Re: Horseshoe-Gallup Unit

In accordance with Rule 11 of the findings of Case No. 2519, Order No. R-2210 concerning the Horseshoe-Gallup Unit in San Juan County, New Mexico, The Atlantic Refining Company requests approval to convert the following two producing wells to injection. These wells were not listed as future injection wells in the exhibits presented by Atlantic at the hearing.

Re: Revision of Flood Pattern
 Horseshoe-Gallup Unit

HORSESHOE GALLUP UNIT W.F.L. NO. 43
SAN JUAN COUNTY, NEW MEXICO

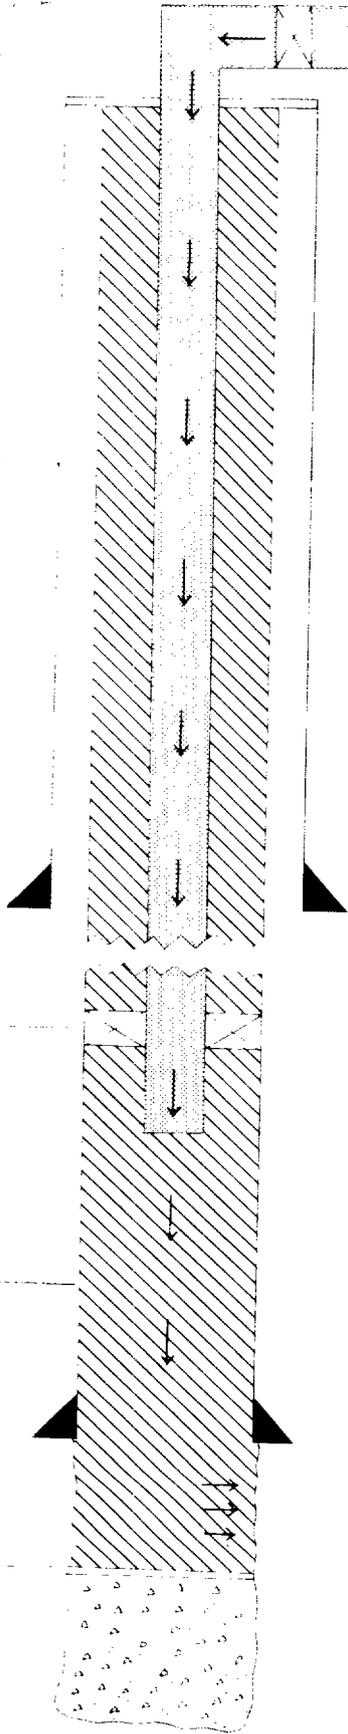
The schematic sketch of the proposed physical equipment of the No. 143 and 145 is attached. As shown on this sketch, injection will be into only the upper Tocito, as the lower Tocito is not developed in this portion of the field. Also attached is a plat showing the locations of the No. 143 and 145 wells, all the wells within the project area, offset operators and offset wells.

495ESHOF GALLUP UNIT #42 - NO. 145
SAN JUAN COUNTY, N.M. DEK 1150

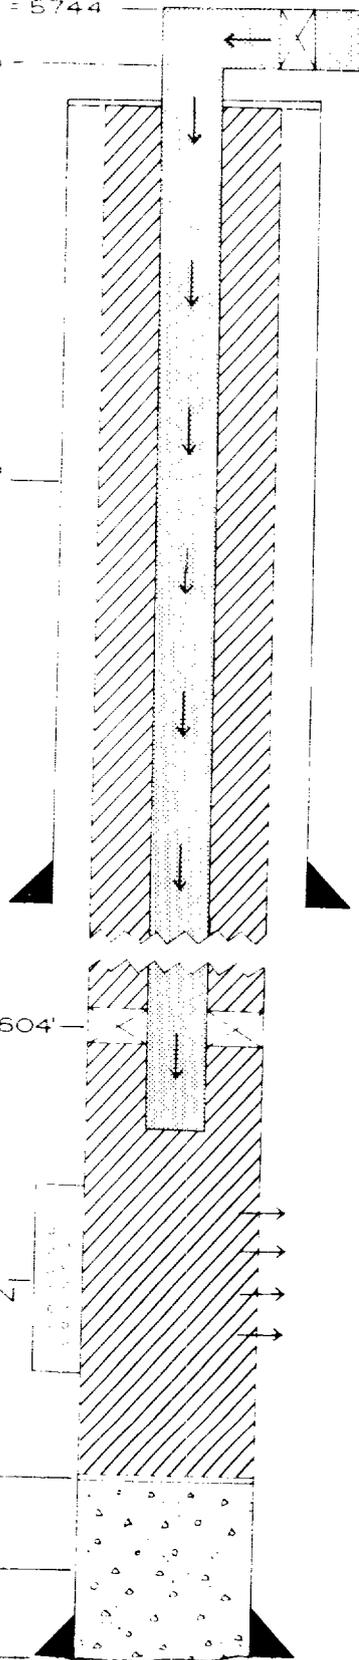
The conversion of the No. 145 is necessary because of a directional permeability problem which has been found to exist between this well and the No. 22 injection well. The No. 22 is located in the NW/4 of the SE/4 of Section 29, T-31-N, R-16-W. The presence of communication between these two wells was established by means of an interference test and also a tracer test. This communication exists to the extent that the No. 145 will produce 100% water when opened and has a shut-in tubing pressure of about 300 psig. The tracer test confirmed that the water produced from the No. 145 is injected water from the No. 22 well. The characteristics of abnormally high pressure and production of a large amount of injected water found in the No. 145 are not present at this time in any other unit wells. Because of the communication, the No. 145 cannot be used as a unit producing well as was previously planned and, therefore, we wish to use it as an injector.
